## ***Interactive comment on “Variation in turbidity with precipitation and flow in a regulated river system – River Göta Älv, SW Sweden” by G. Göransson et al.***

**G. Göransson et al.**

Received and published: 27 March 2013

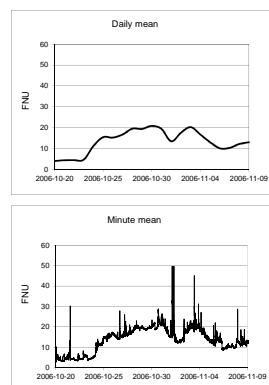
**ANOVA:** The referee questions the performed factorial ANOVA and whether it is appropriate to use it when the variances within the groups are unequal. An analysis of variance is in general done to see whether there are differences in mean values between data from different groups. This is not the type of analysis that is done here, but a factorial analysis. Here, a factor analysis is done between two factors' influence on a third, i.e. two-way factorial ANOVA, because we wanted to study the effect of two independent categorical variables on the dependent variable. We here do the assumption that flow (Q) and precipitation (P) are independent which they in reality are not. The reasoning is that the flow in the studied river is governed by the energy demand and the regulation in the lake Vänern more than it is governed by precipitation. In order to do so, the independent variables are categorized into factors instead of using real values: flow data with river flow 98-150 m<sup>3</sup>/s is given the number 1, flow data with river flow 151-200 m<sup>3</sup>/s is given the number 2, flow data with river flow 201-258 is given the

number 3. The same is done for precipitation. The data is then organized in a table, like:

The factorial analysis is then done by using statistical software. Although the grouping could have been done differently, we believe the results (figure 9 in the manuscript) prove the overall indications given as points under section 4.4. If the referee finds it appropriate, we will include the information above in the revised manuscript to explain the factorial ANOVA better.
